BendPak Technical Service Bulletin

Valve Replacement HD-973

BendPak TSB 95-072022

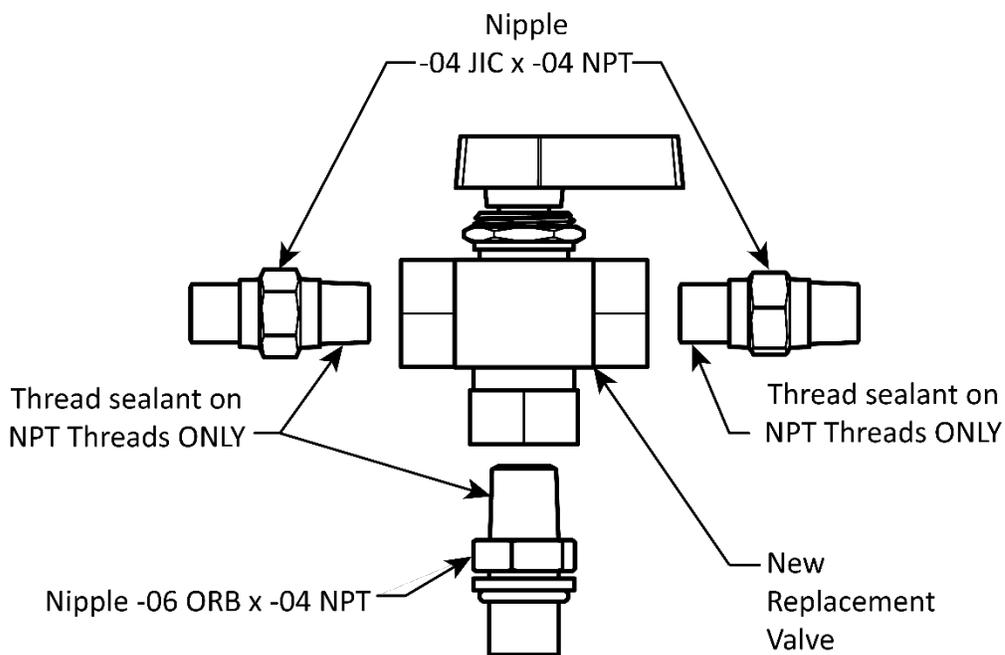
The purpose of this Technical Service Bulletin is to remove and replace the original three-way Platform Selector Valve. In its place, install the new and better performing, higher psi rated valve enclosed with this TSB. The new replacement valve is designed for increased endurance for the HD-973 application.

Discard the originally supplied 2500 psi Platform Selector Valve from the HD-973 Parts Bag and install the new valve as directed in the installation manual. Apply Thread Sealant to the NPT threads only; no sealant is used on the outer JIC threads.
